**Public Hearing  
CITY OF AUSTIN  
RECOMMENDATION FOR COUNCIL ACTION**

**SUBJECT:** Set a public hearing on an appeal by Ed King (Long Canyon Home Owners Association, Phase I) and Joseph Konopka (Long Canyon Home Owners Association, Phase II/III) of the Zoning and Platting Commission's decision to grant a Hill Country Roadway Site Plan with waiver/variances for Potter's Dentistry at 7901 FM 2222 (site plan no. SPC-04-0022A). (Suggested date and time: February 10, 2005, at 6:00 p.m.)

**ZONING & PLATTING COMMISSION SITE PLAN  
HILL COUNTRY SITE PLAN REVIEW SHEET**

**PROJECT NAME:** Potter's Dentistry

POTTER DENTISTRY  
7901 FM 2222, AUSTIN TEXAS 78730  
SITE PLAN/DIMENSION CONTROL PLAN

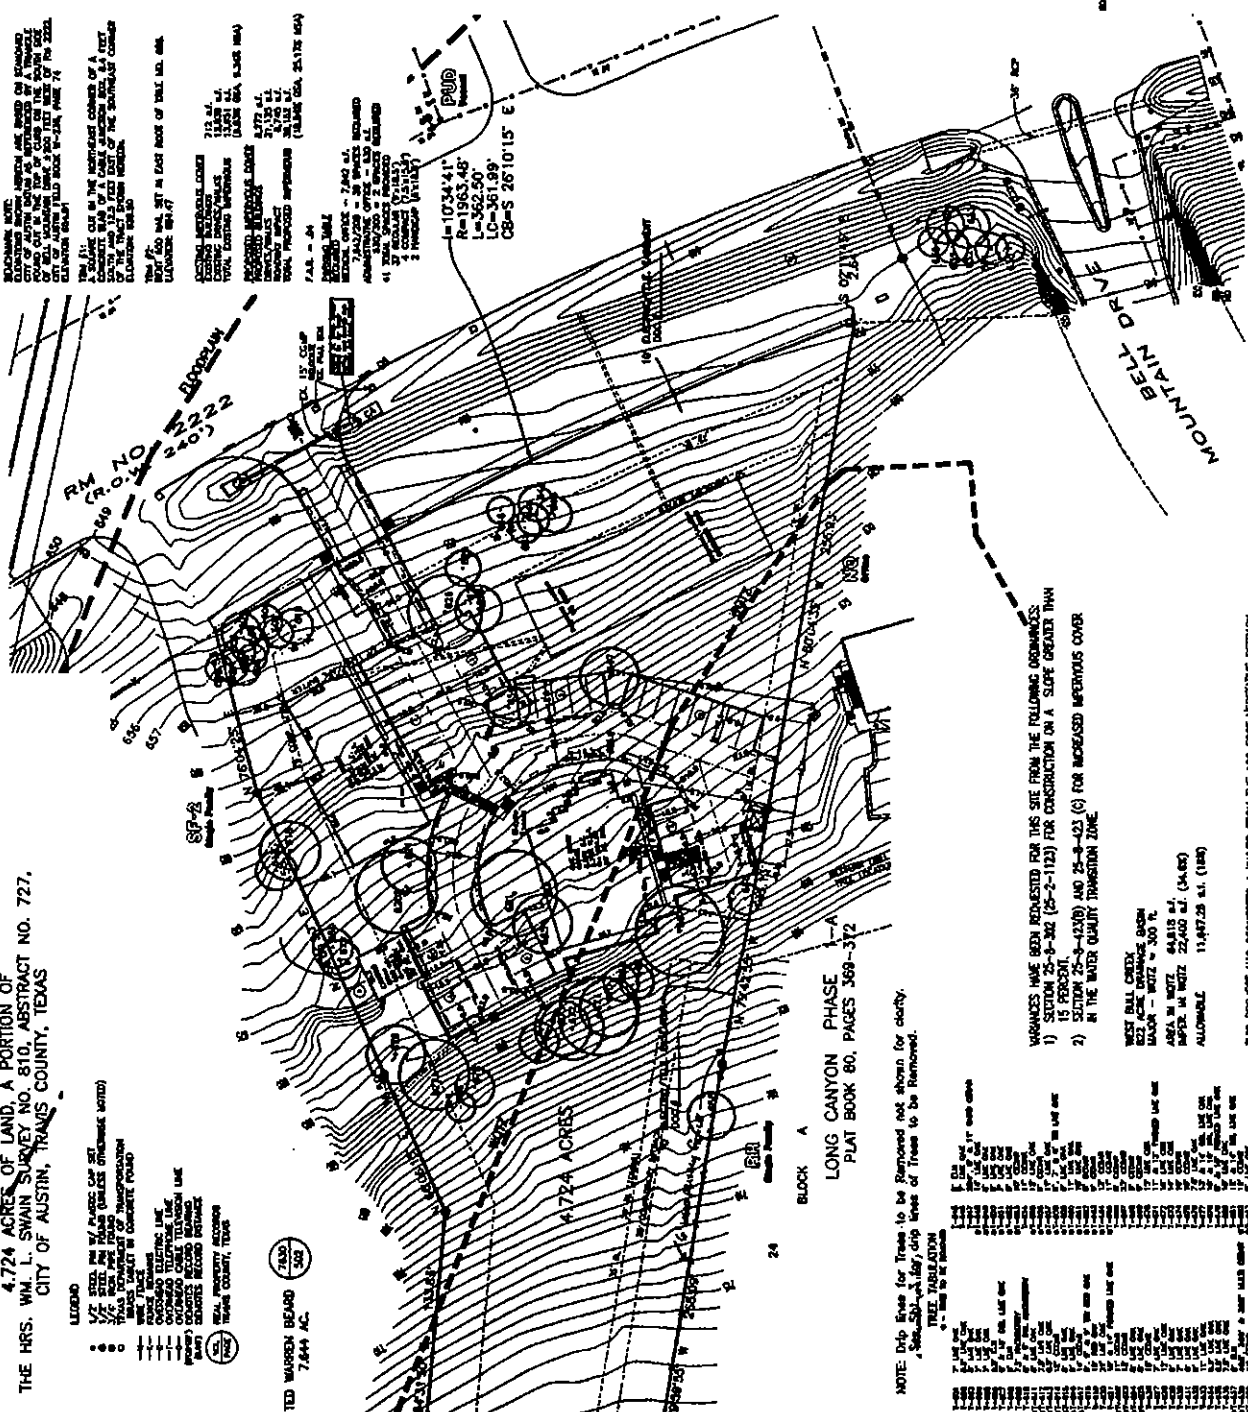
Variance #2: 25-8-423: To exceed allowable impervious cover in the Water Quality Transition Zone (may not exceed 18% in WQTZ; applicant is proposing 27%). Not Recommended: by staff; recommended conditional approval by Environmental Board.

**NOT RECOMMENDED:** The findings of fact have NOT been met; therefore, Staff does not recommend approval of this variance. Staff believes this site may be developed with the requirement that WQTZ not exceed the 18% limitation.

- 1) SECTION 25-B-302 (25-2-112) FOR CONSTRUCTION ON A SLOPE GREATER THAN 15 PERCENT.
- 2) SECTION 25-B-423(b) AND 25-B-423 (c) FOR INCREASED WEEDS COVER IN THE WATER QUALITY TRANSITION ZONE.

THIS PROJECT HAS REQUESTED A WAIVER FROM THE 100 FOOT VEGETATIVE SETBACK

**RECOMMENDED:** The findings of fact have been met. Staff recommends approval of the variance from Section 25-8-301 & 302 with the following conditions:

1. All cut/fill to be structurally contained
2. All replacement trees to be Class 1 trees, container grown from native seed.
3. All COA required landscaping to utilize Grow Green Native or Adapted Materials
4. Provide an Integrated Pest Management Plan.
5. Forbid the use of cold-tar based parking lot sealants.

WQTZ AREA 87,945 s.f.  
 IMPERVIOUS ALLOWED IN WQTZ (18%) 15,830 s.f.  
 PROPOSED IN WQTZ (25.4%) 22,453 s.f.  
6,623 s.f.

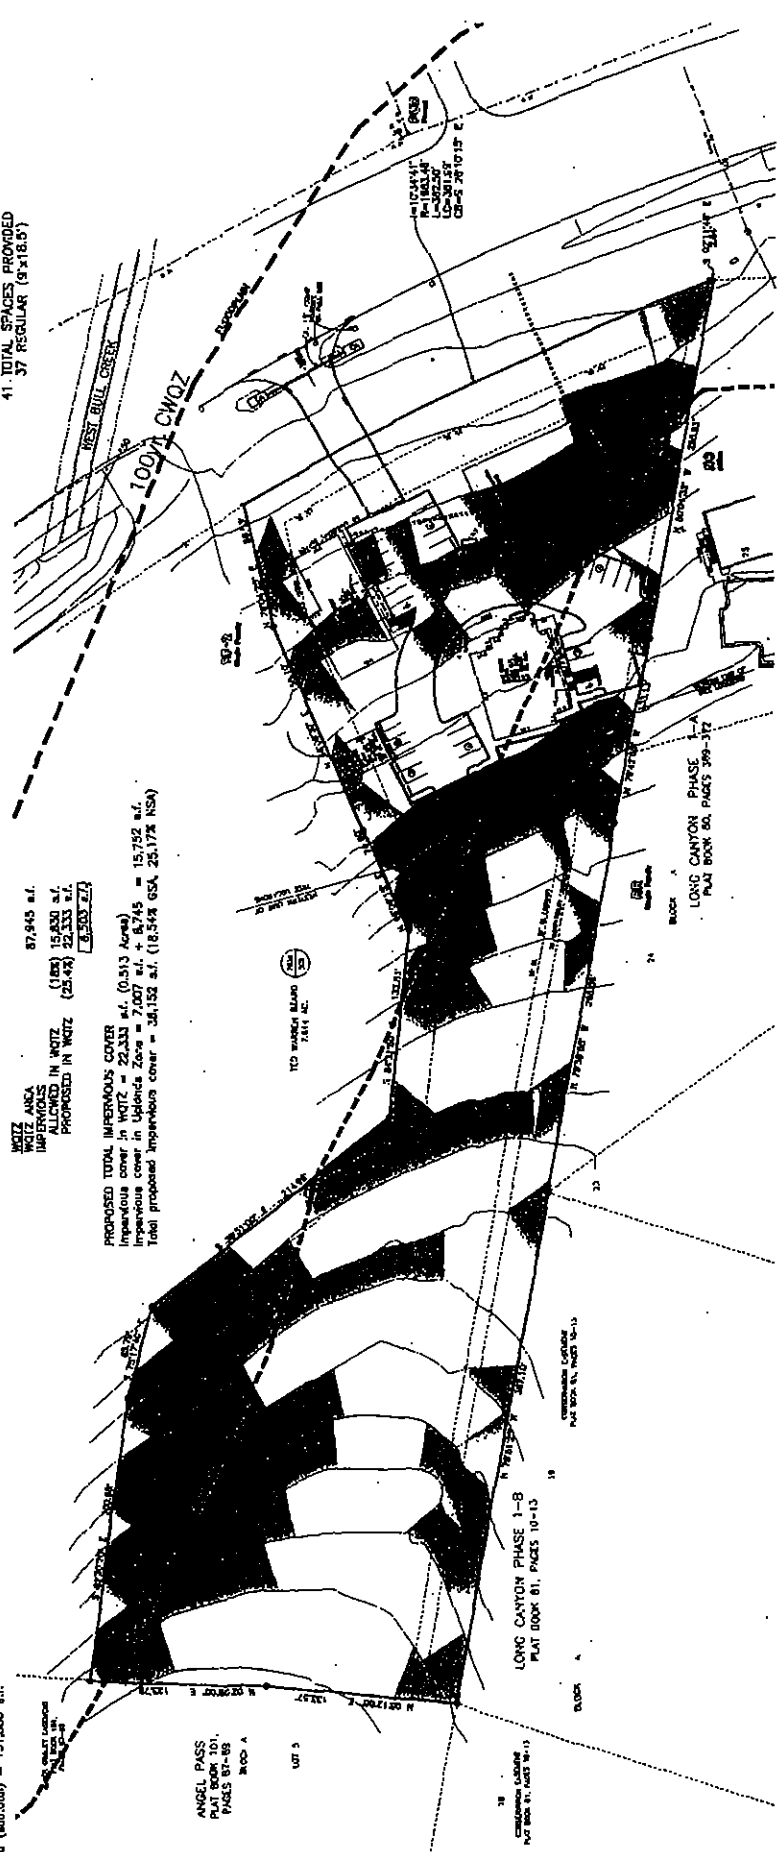
**No/ The variance is based on the method chosen by the applicant to develop the property, and the method of development does not provide greater overall environmental protection than is achievable without the variance.**

**No/** Per the previous finding, Staff has determined that the requirement for which the variance is requested does not prevent a reasonable, economic use of the entire property. Therefore, the variance cannot be considered the minimum change to allow a reasonable, economic use of the entire property.
